Required Fuel Filter Replacement 40 thru 275

MARINER AND MERCURY MODELS WITH IN-LINE FUEL FILTERS

Figure 1.

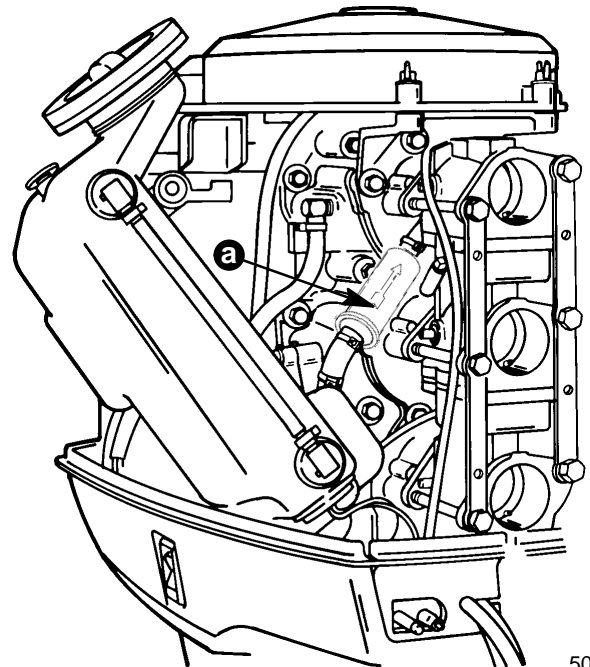
Outboards listed, require the replacement of the in-line fuel filter (Figure 1) to prevent the possibility of fuel leakage. Affected in-line fuel filters may develop a leak at the sonic weld area. (Figure 2)

Figure 2.

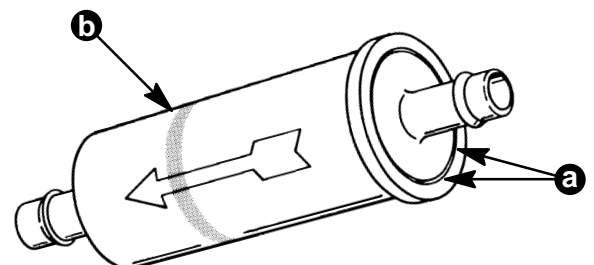
A blue or black marker ring around the fuel filter body (Figure 2) indicates filters that DO NOT have to be replaced.

Inspect all p/n 35-816296--1 fuel filters in your service stock. Return, with a warranty claim, any unused filters that do not have a blue or black marker ring.
